**RE: Response to Comments from Proposed Data Center Noise Impact Assessment
 1960 W. Lucent lane, Naperville, Illinois 60563**

Jacob and Hefner Associates, Inc. (JHA) is pleased to present this Response to Comment (RTC) letter addressing recommendations and inquiries from Hampton, Lenzini and Renwick, Inc.'s (HLRs) review titled *Karis Critical Development (1960 W. Lucent Lane) – Review of Noise Impact Assessment Report and Recommendations*, dated October 2, 2025. Specific alterations to the model, comparisons of model output to regulatory limits, and clarification of model details, as noted in HLR's review, are addressed in the updated Noise Impact Assessment (NIA) (**Attachment 1**) and in responses below.

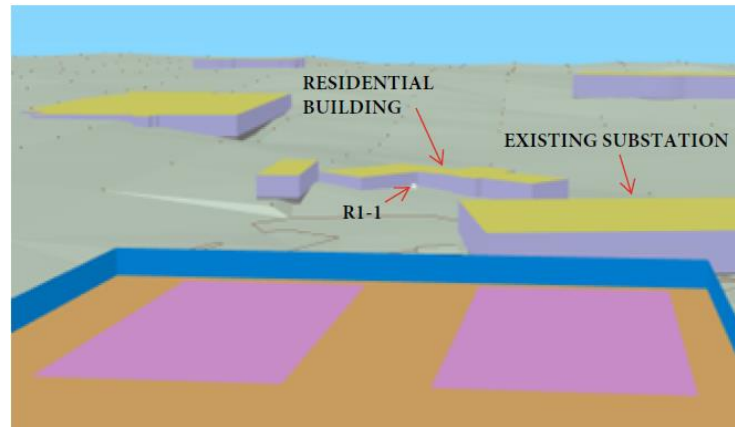
“Please confirm that the ‘auxiliary’ building representing the substation is accurate size and shape in SoundPlan to ensure accurate shielding effects”

The existing substation building and walls shielding the R1-1 receptor from property-line noise sources is set at 19 feet in total height. The corners of the building/walls are set into the ground slightly. Though the height is variable above ground given the variation in grade, the height near the corners of the wall nearest to the R1-1 receptor are approximately 16 feet in height. Since most of the noise impact at R1-1 is from rooftop HVAC units, and the substation does not break line of sight from the top of the parapet wall with the current receiver location. The shielding effects of the substation walls are not significantly effective in reducing noise propagation from the proposed data center noise for the current Leq-N model (Figure 4 on the NIA). A 3D image of the line-of-sight between the rooftop parapet and Receiver R1-1 is provided below for visual context.
